iPod Nano 6 Display Breakout - Bug #601

TLV61220 footprint wrong

picture963-1.png	7.46 KB	03/18/2015	Andrew Kohlsmith

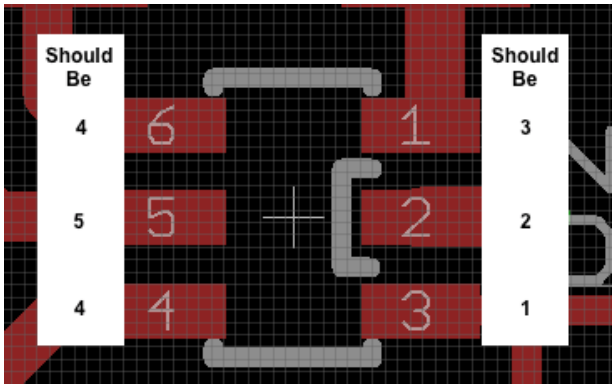
The SOT23-6 footprint I created is mirrored top-to-bottom (i.e. pin 1 is pin 3, pin 4 is pin 6).

The layout'll have to be fixed. I've updated the library but I wonder what other SOT23-6 parts I have that are wrong.

For now the fix for this board is to take the pins and bend them backward and mount the part upside down.

Footprint fixed in commit:122c7eb.
